Overview: Production error in version 1.0 harnesses; The immobilizer wire (orange/black) is in pin position #4 instead of pin position #5. Although an effort to correct the issue was made, some quantity of harnesses did get shipped before the issue was spotted. We are advising to inspect the harness BLADE connector before attempting to install harness or program the module. This issue is not known to affect the version 2 harnesses, which require no modification.

Overview: Early versions of the FTI-STP1 harness require modification for **automatic transmission (AT)** applications, some of the product was able to be modified before release, but a small quantity was released without modification.

MODIFICATION REQUIRED FOR A/T APPLICATIONS, ONLY WITH v 1.0 HARNESS

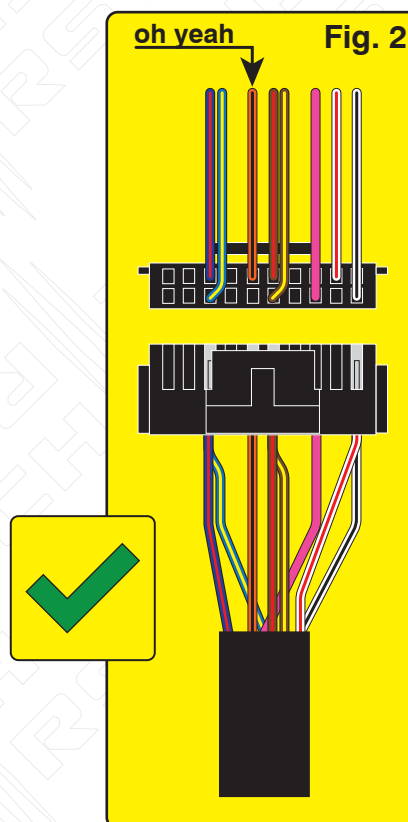
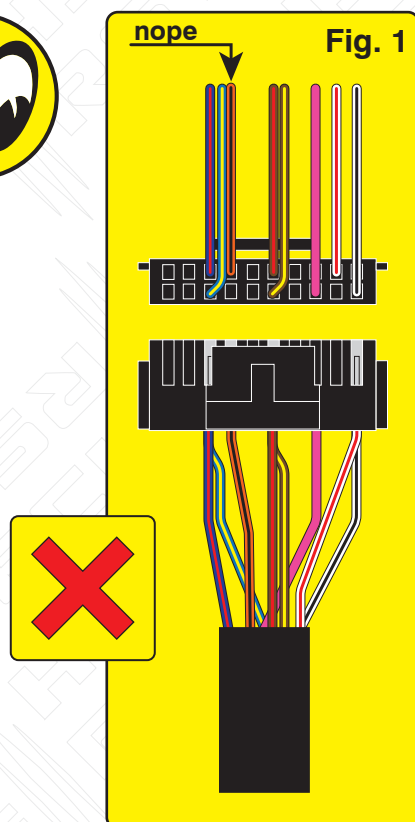
Issue: Module fails to program correctly to vehicle, does not allow the vehicle to be remote started.

Correction: Step 1.) Locate the orange/black wire and confirm whether it is positioned as illustrated in Fig. 1 or Fig. 2. If the wire is as illustrated in Fig.1, proceed with Step 2 through 5 and complete the repair procedure outlined, if the wire is as illustrated in Fig. 2, correction is not necessary, proceed with harness installation and module programming.

Step 2.) Using a pick, lightly depress the catch that secures the terminal in the housing then remove the wire and terminal from the housing.

Step 3.) Using a fine tip razor or utility knife, insert the blade beneath the terminal catch and raise it slightly, so that it can be reused to secure the terminal when reinserted into the BLADE connector housing.

Step 4.) Refer to Fig. 2 for correct position of the orange/black wire (next to brown/red) then reinsert the terminal, pressing lightly until the catch 'snaps' into place, securing the terminal in the connector housing.

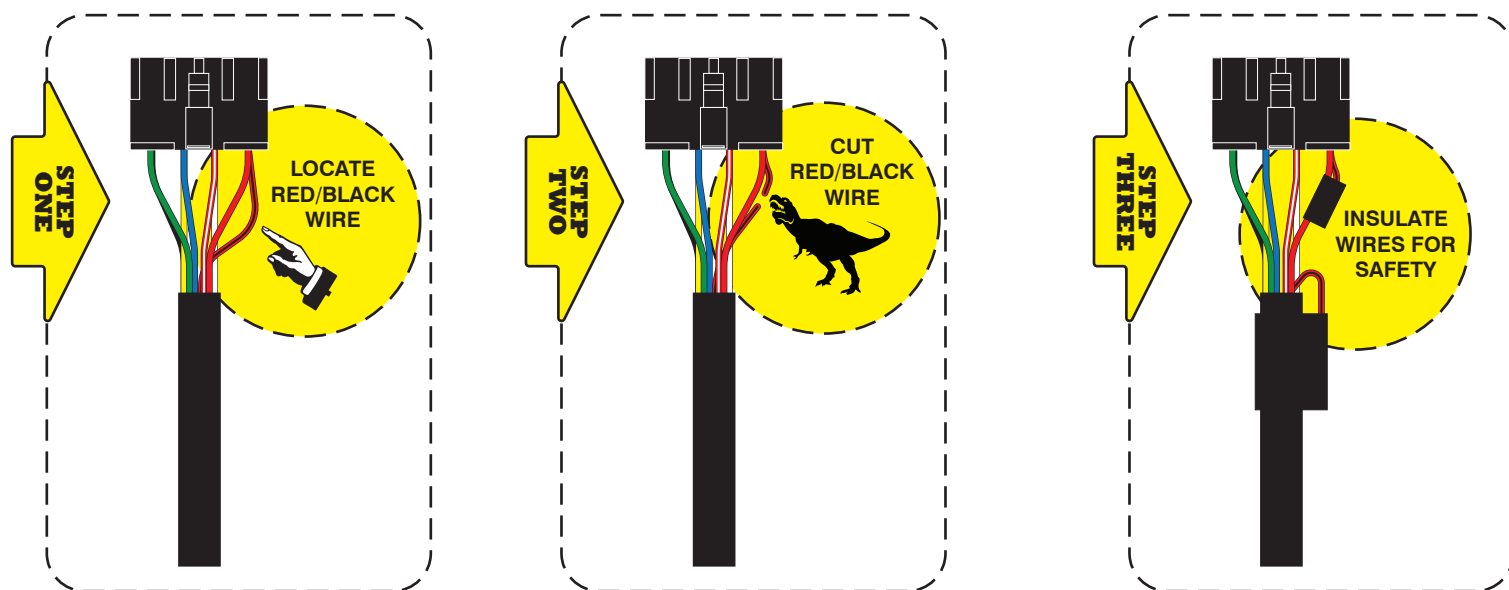
Issue: The FTI-STP1 T-harness has been designed to be compatible with A/T (automatic transmission) & M/T (manual transmission) applications, but due to an oversight in early production runs, the selection was defaulted to M/T mode.

Using a harness configured for an M/T application, in an A/T equipped vehicle, could result in vehicle module damage, it is advised that the harness be returned to A/T mode before installation in vehicles equipped with an automatic transmission.

Correction: Locate the **red/black (+ Clutch)** wire provided in the CN1 connector of the main harness assembly. Cut the **red/black** wire, either flush to the CN1 connector, or leaving enough wire exposed so that you can insulate and secure the ends of the wire that remain after cutting. Insulate each of the remaining ends of the **red/black** wire and secure to prevent any possibility of a short circuit. **If the red/black wire has already been disconnected, no further modification is required for A/T applications**
